**RE: Caminito Verde Subdivision
2827 Rio Grande Blvd NW
Grading & Drainage Plan
Engineer's Stamp Date: 02/11/2026
Hydrology File: G12D002
Case # HYDR-2026-00053**

Based upon the information provided in your submittal received 02/19/2026, the Grading & Drainage Plan is approved for Grading Permit and Building Permit. Please attach a copy of this approved plan in the construction sets for Building Permit processing along with a copy of this letter.

Caminito Verde Subdivision

GRADING & DRAINAGE PLAN

ASIA W. WILSON-ENGINEER
NEW MEXICO
17631
PROFESSIONAL ENGINEER
02/11/2026

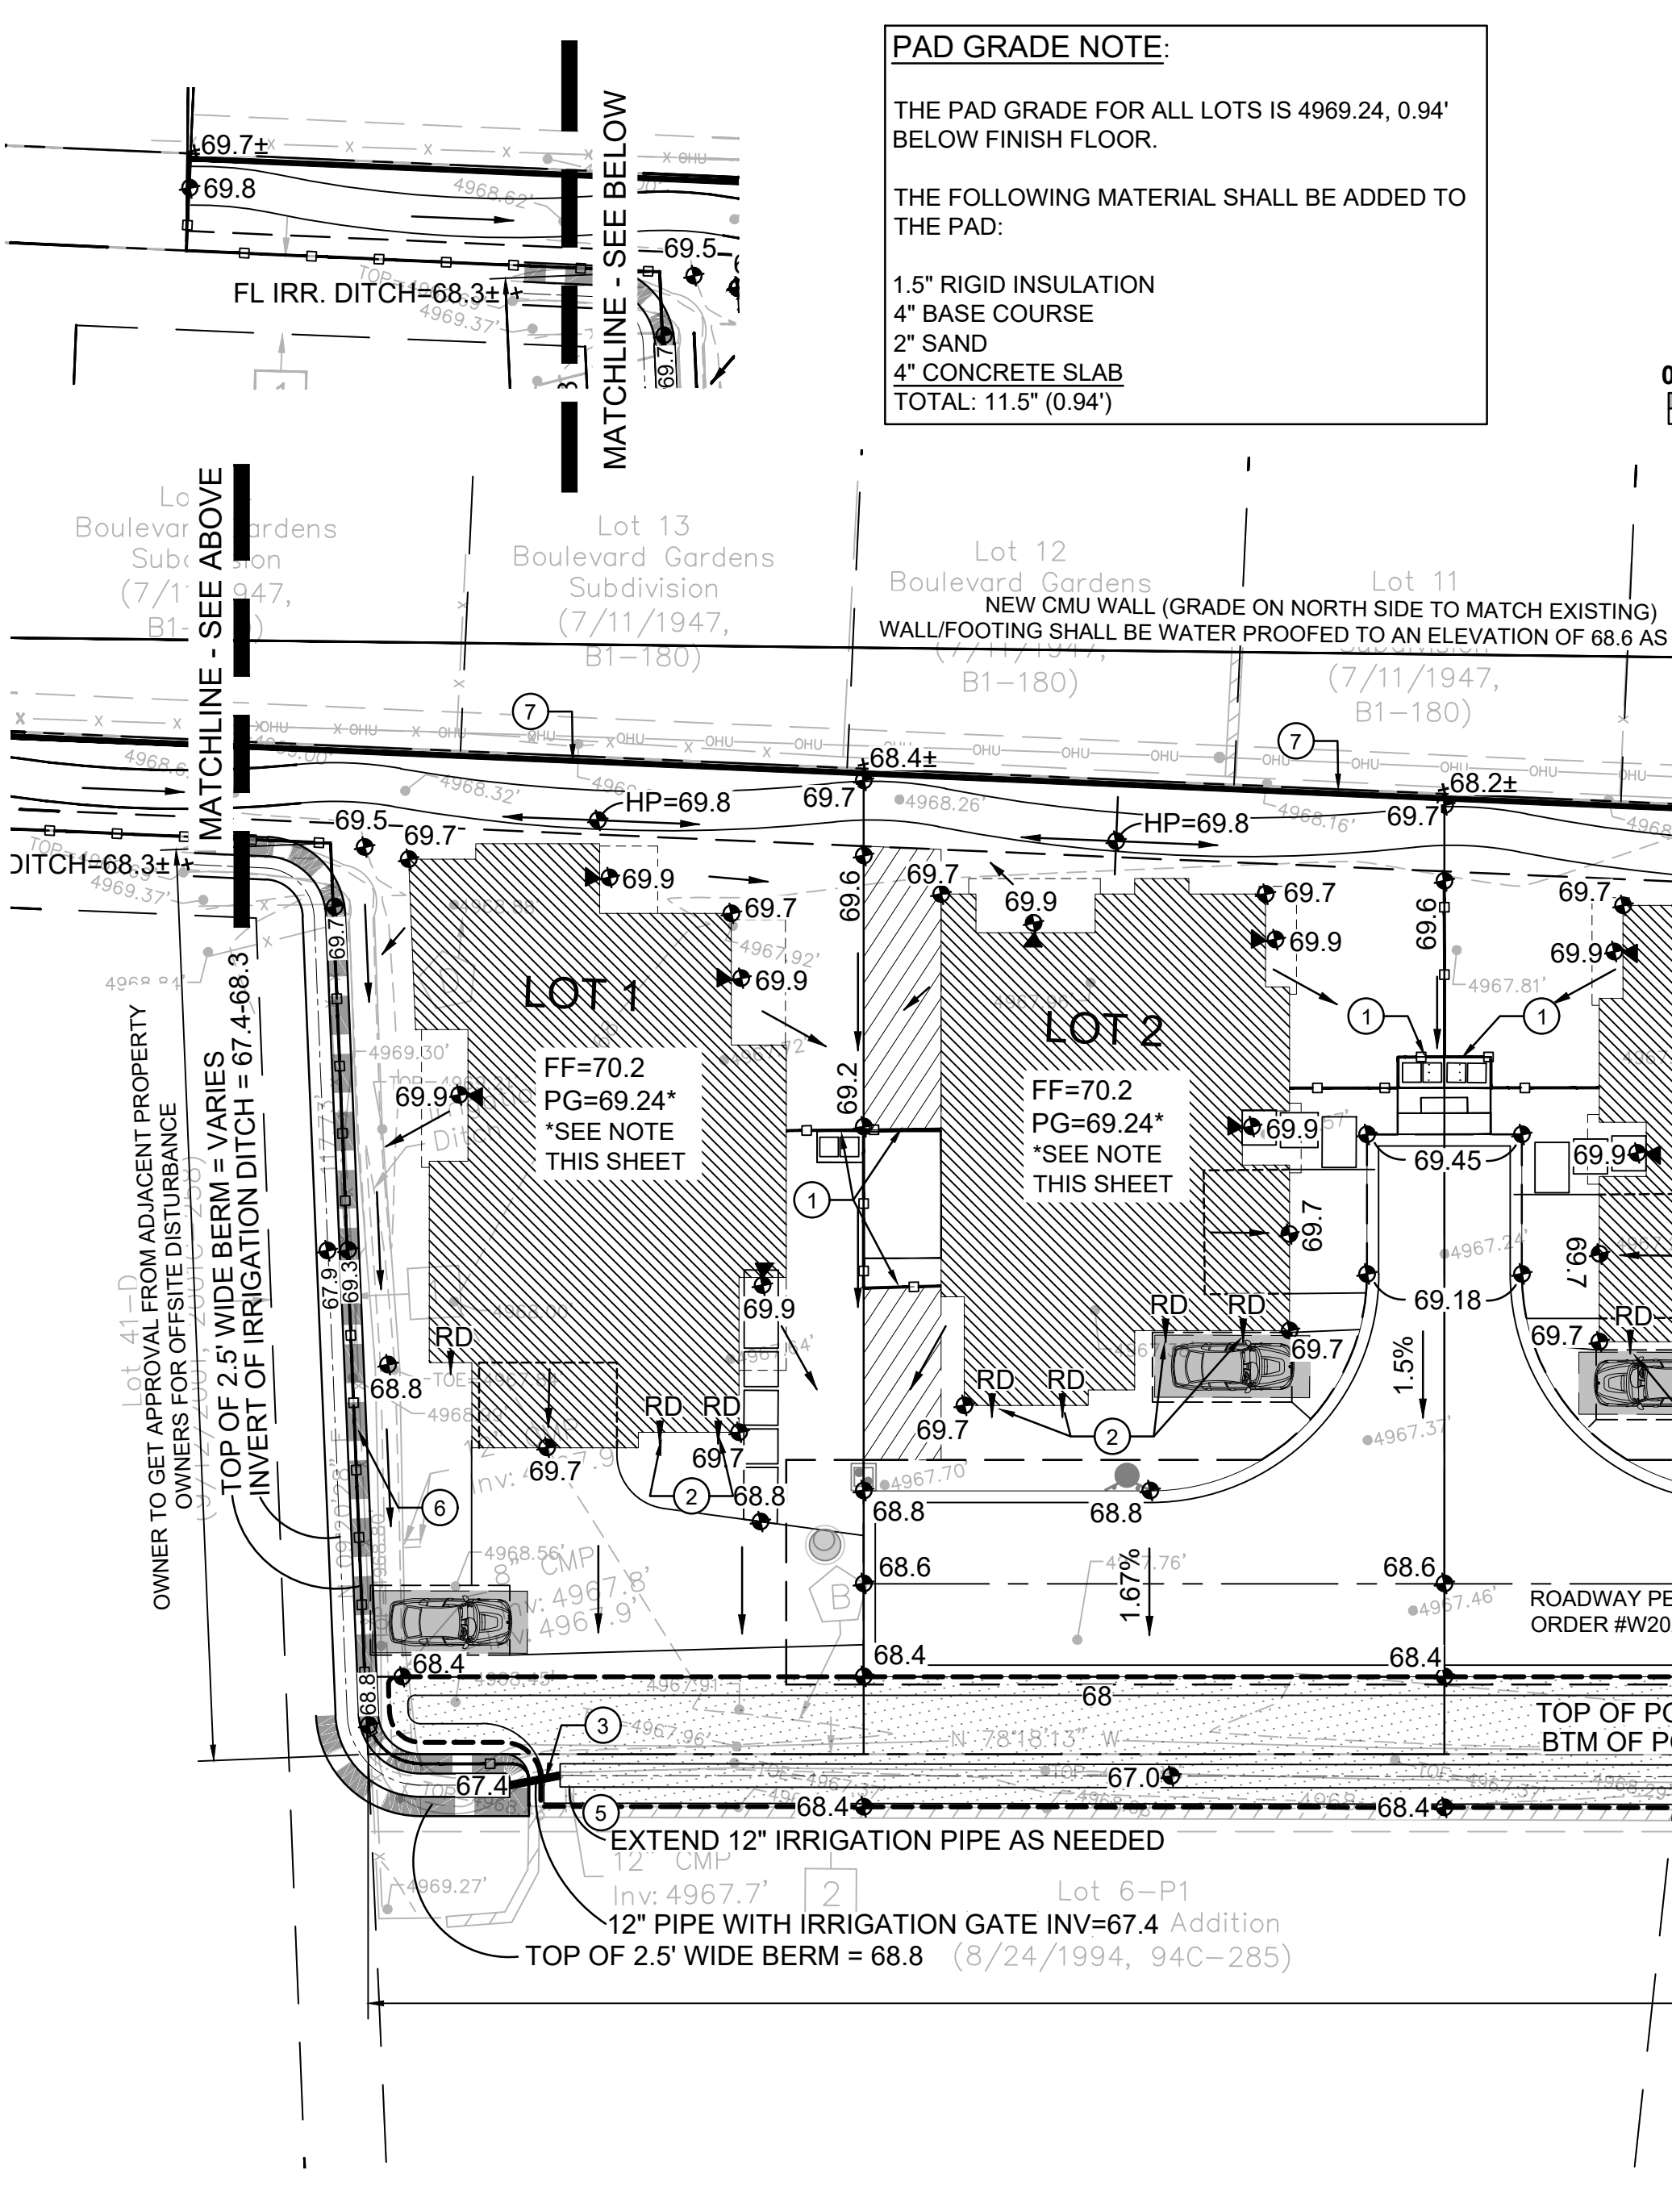
1. Engineer's Certification, per the DPM Part 6-14 (F): Engineer's Certification Checklist For Non-Subdivision is required.
2. Please provide the Drainage Covenant with Exhibit A for the stormwater quality ponds per Article 6-15(C) of the DPM prior to Permanent Release of Occupancy. Please submit the original copies along with the \$ 25.00 recording fee check made payable to Bernalillo County to the Hydrology Section of Development Review Services on the Ground floor of Plaza de Sol.
